Civil Engineering Infrastructure Report & Flood Risk Assessment

RESIDENTIAL DEVELOPMENT AT COOKSTOWN ROAD, ENNISKERRY, CO. WICKLOW

DOCUMENT NO: 18.243 – IR – 01

JBA Project Code 2020s1192
Contract Residential Development Cookstown, Enniskerry, Co. Wicklow
Client Cairn Homes Properties Ltd.
Date 03rd November 2020
Author Jamie Cullen
Subject **Stormwater Audit - Stage 1 Report**

DRAWING NO: 18243-BMD-00-XX-DR-C-1020
 SHEET: PL3

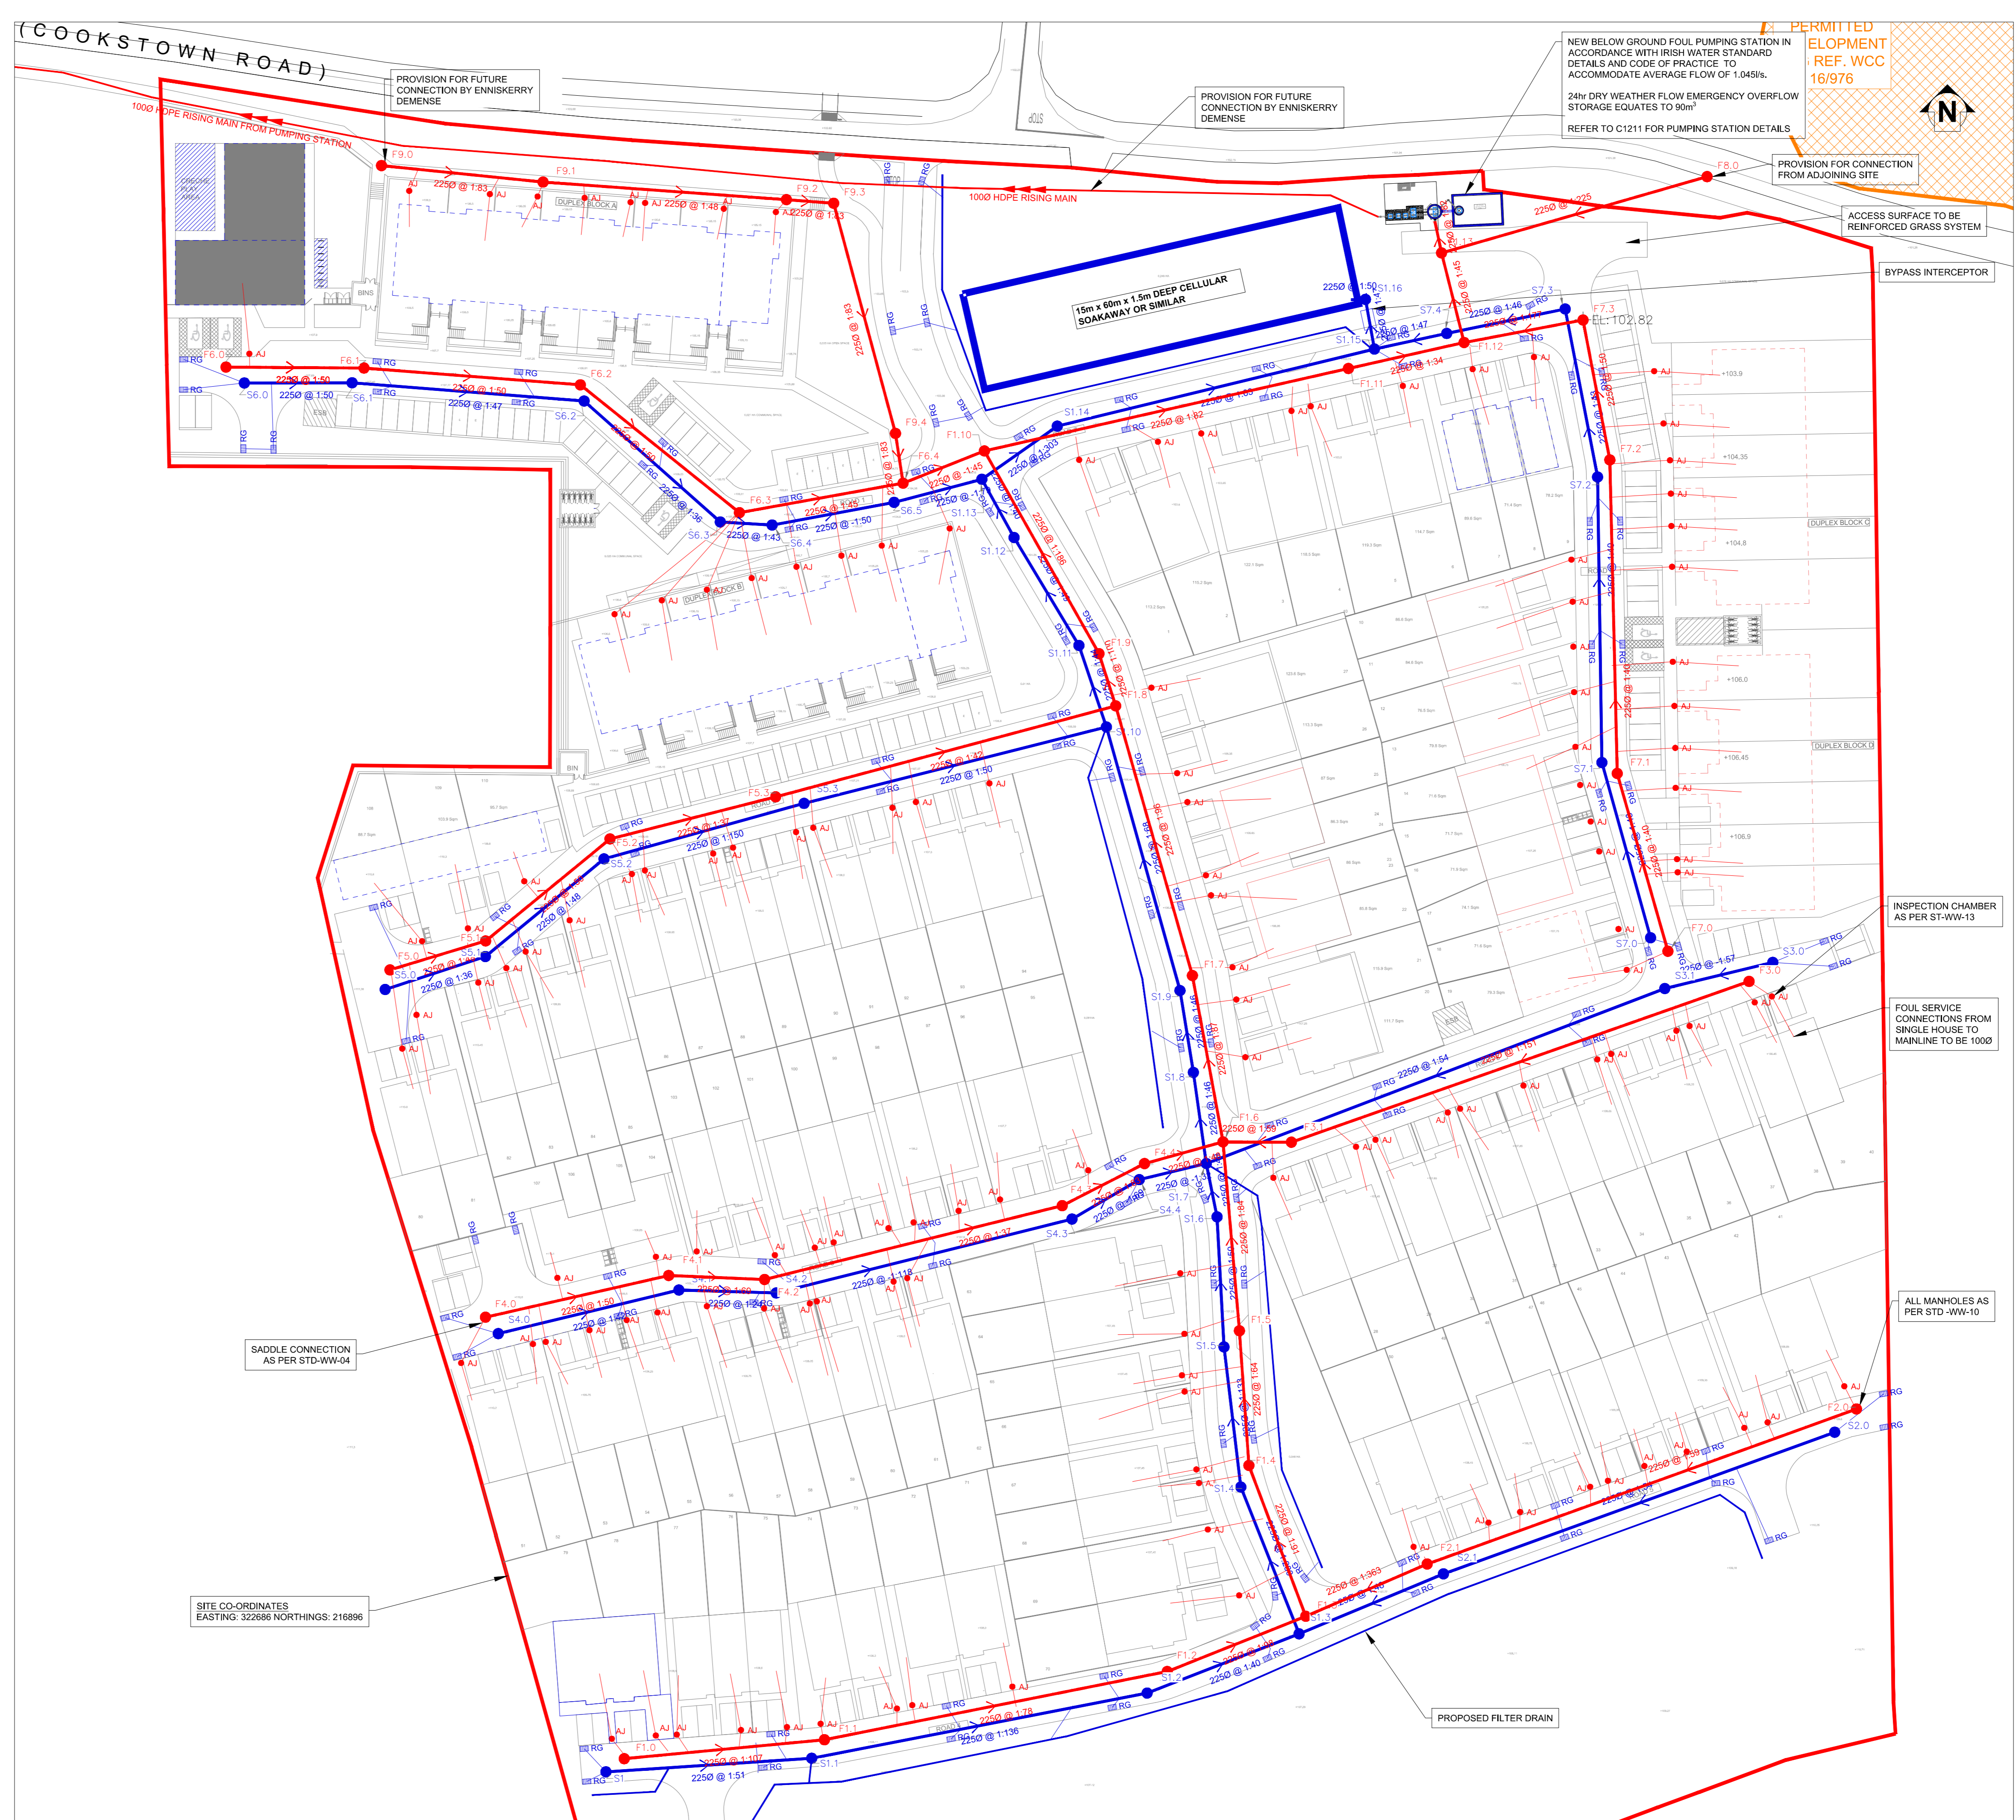
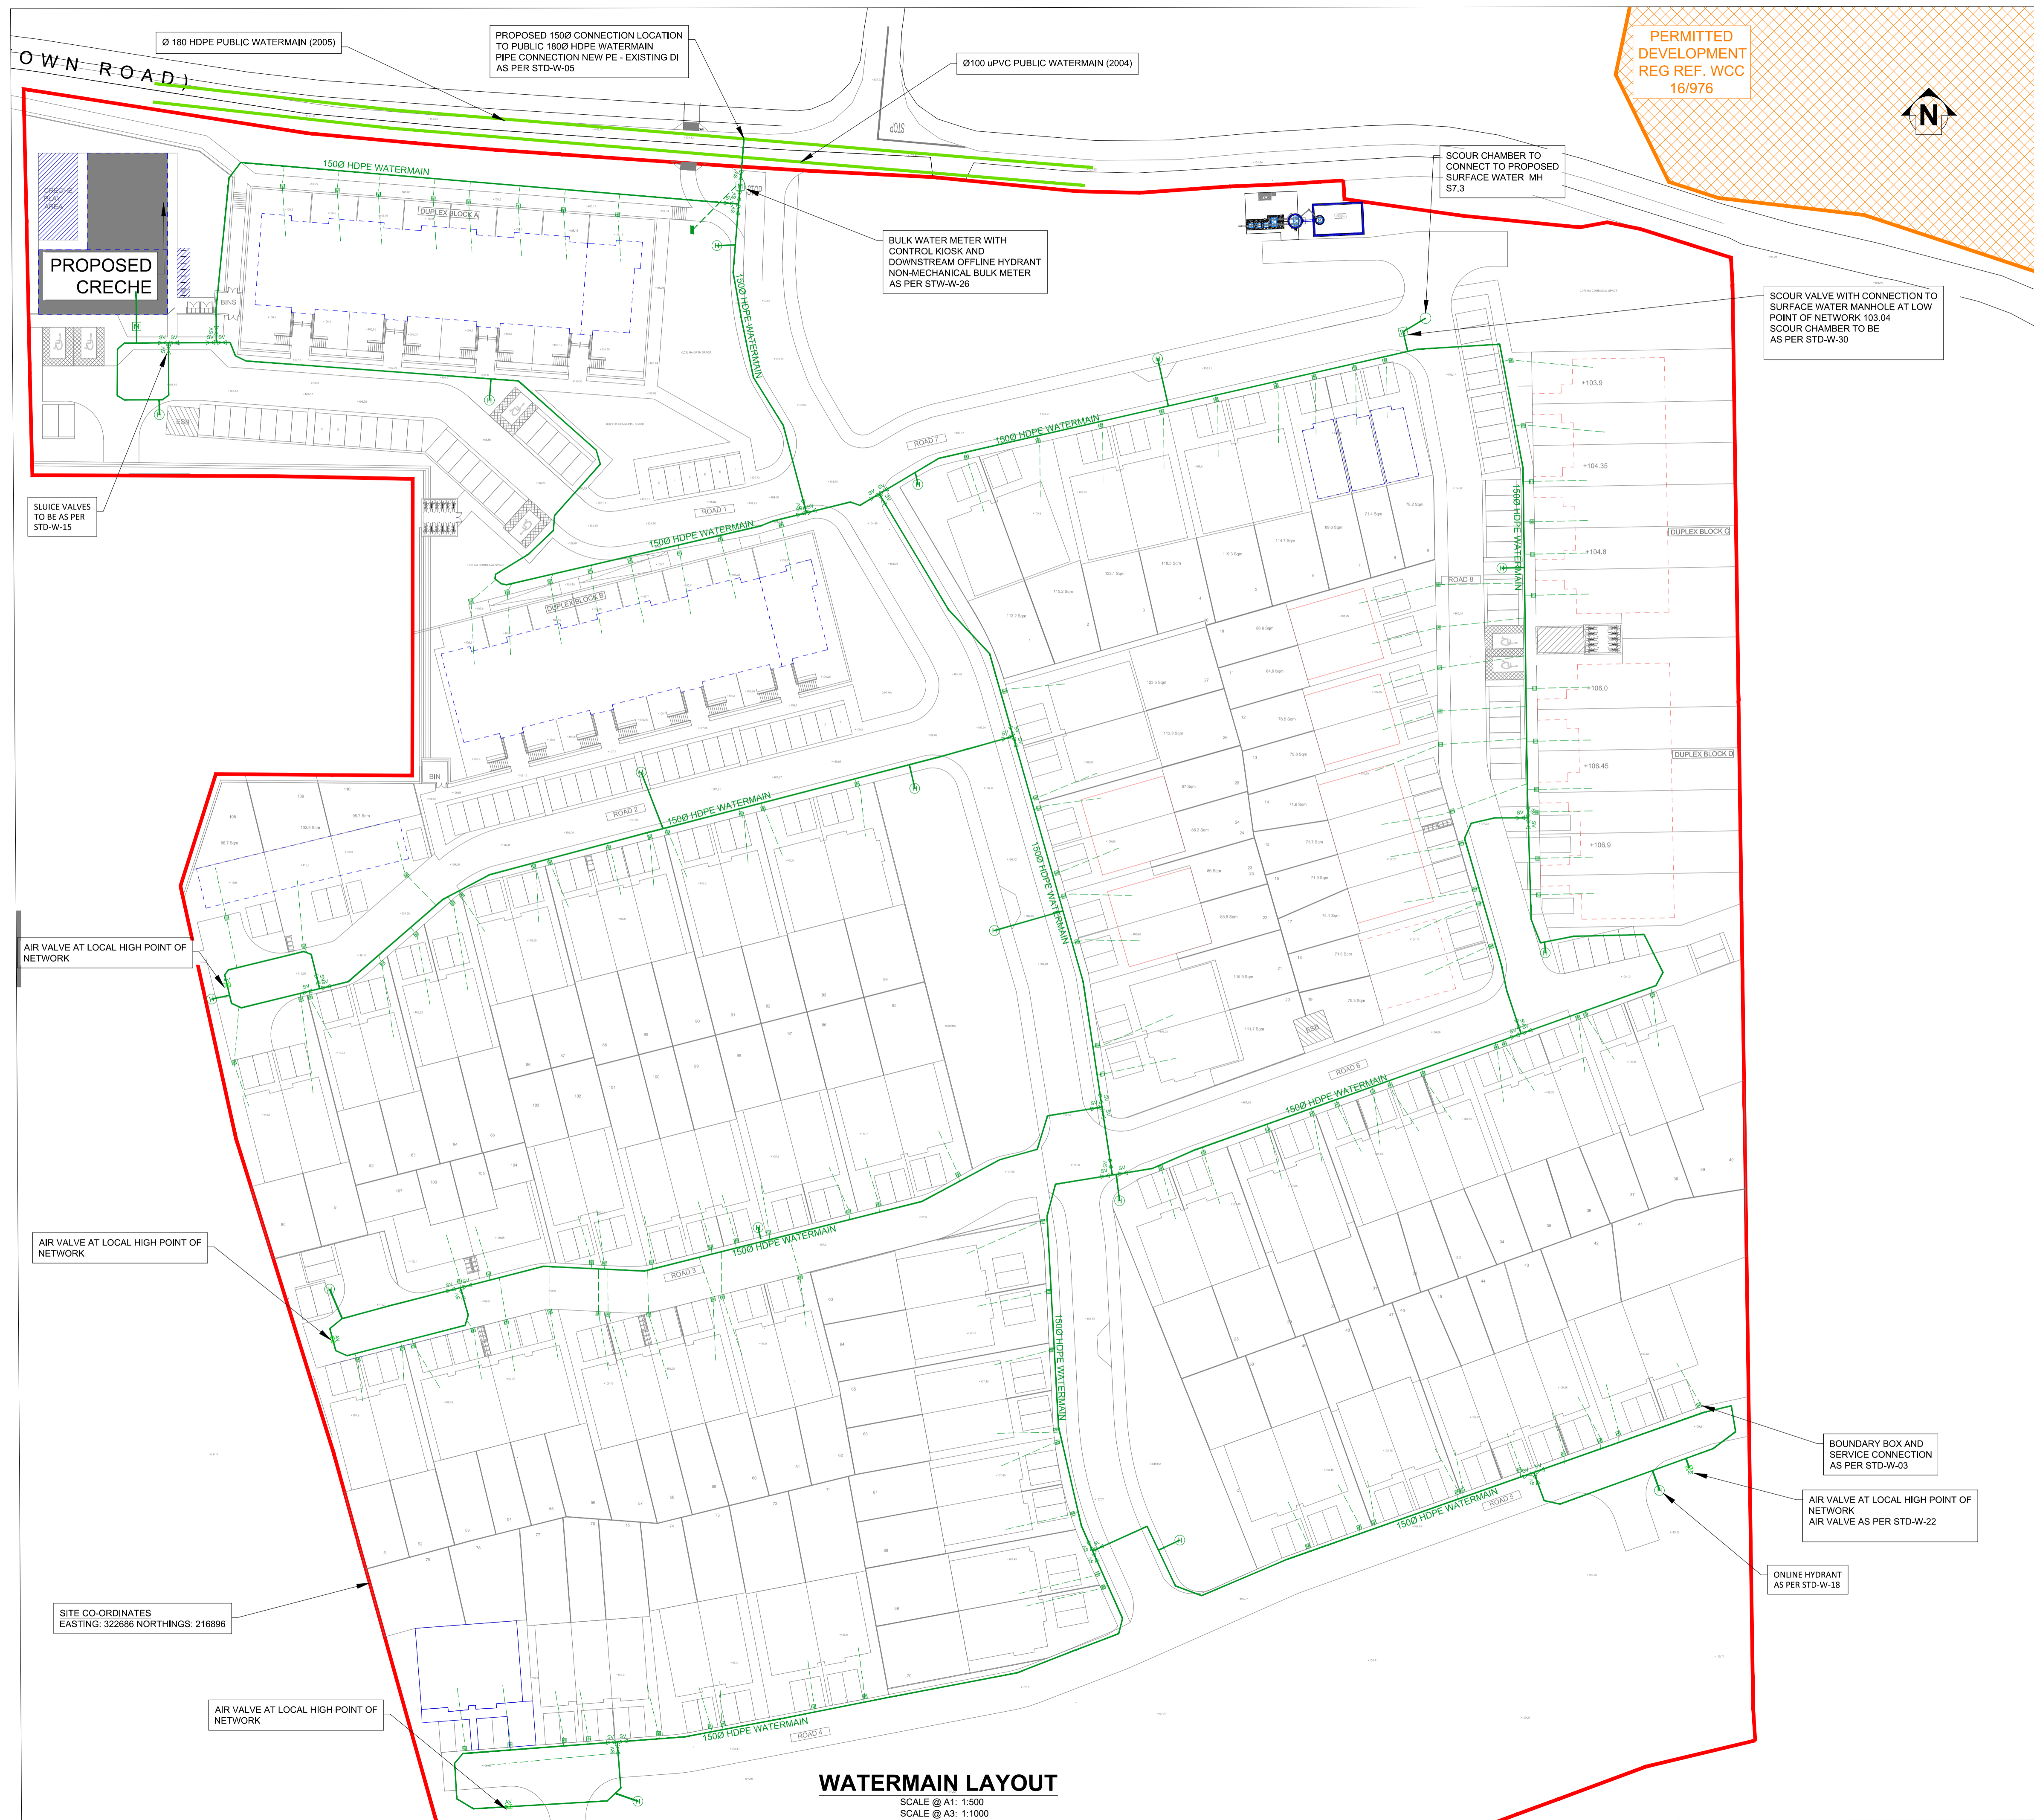
<p>There are inconsistencies between the pipe size and gradient information contained on drawing C1020 and the Micro Drainage analysis. Very flat gradients with poor self cleansing characteristics will not be acceptable.</p>	<p>These inconsistencies have been addressed in the updated drawings.</p>
<p>A cover and invert level data table should accompany drawing C1020 and adequate information should be available to show that the top water level in the proposed soakaway is below the formation level of the adjacent public road.</p>	<p>Manhole schedules have been provided on the updated drawings. The top water level in the soakaway for a 100 yr storm + 20% climate change is below the level of the adjacent Cookstown Road.</p>
<p>Infiltration test results and analysis of the infiltration capacity of the site along with details of measures to demonstrate that surface water cannot flow onto the public road should be provided.</p>	<p>Infiltration test results are contained in Appendix VIII of this report. Surface water is drained to the soakaway. The top water level in the soakaway for a 100 yr storm + 20% climate change is below the level of the adjacent Cookstown Road</p>

2	In Appendix VI the Surface Netwrok Design pg. 2 to 5 the diameter and falls of individual pipe runs do not match what is shown on drawing's 1020, 1120 and 1121 (the drainaeg plan and longitudual storm sections).	Barrett Mahony to review and advise	This has now been rectified.	See Note 14
3	In the flow results on page 2 the infiltration trenches are shown IC1 to IC15, however, they are not labelled on drawing 1020 so it is hard to pinpoint where these are in relation to on site.	Barrett Mahony to review and advise	This has now been rectified.	Acceptable
4	In terms of source control and avoiding the conveyance of all storm flows to a single soakaway system towards the northern boundary of the site, does the filter drain along the southern side of road 4 need to connect to the dedicated storm network	Barrett Mahony to assess if a standalone soakaway system could/should be provided within the green area to the south of the site for road 4 drainage and/or runoff from the green open space itself.	A 1.2.m x 06m infiltration trench has been proposed to allow for Road 4 to be treated locally as suggested.	Acceptable

22/10/2020			
14	On drawing 1020 the pipe diameters and the slopes have been updated however, these do not match the pipe and slopes shown on drawing 1120 & 1121. There seems to also be no consistency with values in the FLOW results and drawings for example, S1.5 to S1.6 in FLOW is shown to be 300mm diameter pipe at 1:150 slope, on drawing 1020 this pipe run is shown to be 300mm diameter pipe at 1:134 slope and on drawing 1120 this is shown as 225mm diameter pipe at 1:151 slope. Another example S1.8 to S1.9 in FLOW is a 375mm diameter pipe at 1:200 slope, on dwg. 1020 this pipe run is shown to be 450mm diameter at 1:200 slope and on drawing 1120 it is a 225mm diameter at 1:201 slope.	Barrett Mahony to review and advise	Flow model and drawings have been amended to show consistent information.	Acceptable
15	In the design settings section of FLOW this gives the information on what the FLOW output is calculated from, the time of concentration and rainfall intensity can be added to the Links results in the FLOW software and be displayed on pg. 2, 3, 4 & 5. It is also noted that no simulation settings have been provided for the storm events.	Barrett Mahony to review and advise	TOC and rainfall intensity have now been added to link results. Simulation settings have also been added to report output (pg 11+12).	Acceptable

16	On Dwg. 1020 S7.0 to S7.1, S7.1 to S7.2 & S7.2 to S7.3 are shown to have slopes of 1:40. In the FLOW output & Dwg. 1121 for these three pipe runs the slopes are shown to be 1:150, 1:150 & 1:200 respectively, the longitudinal section shown on Dwg. 1121 received on the 21/10/20 is displaying the same as the drawing received on the 30/09/20.	Barrett Mahony to review and advise	Flow Model and longsections have been amended to reflect the 1:40 slope required to minimise surface water manhole depths.	Acceptable
17	This is an acceptable flood risk threshold level. We note that the initial FLOW results received on the 30/09/20 indicated no flooding, however, the latest FLOW results received on the 21/10/20 indicates flooding occurring at S1.3 during the 100-year storm + 20% climate change and given the proximity to the raised speed table on the northern side of the T-Junction, there is potential for the build up of water at this location. Given the road level at this location is the same as the FFL of the semi-detached houses on the west side of the junction, and although the predicted flood volume is small, there is a potential flood risk.	Barrett Mahony to review and advise	This has been amended to eliminate the flooding simulated at S1.3. No flooding occurs in the revised model for any storm event.	Acceptable
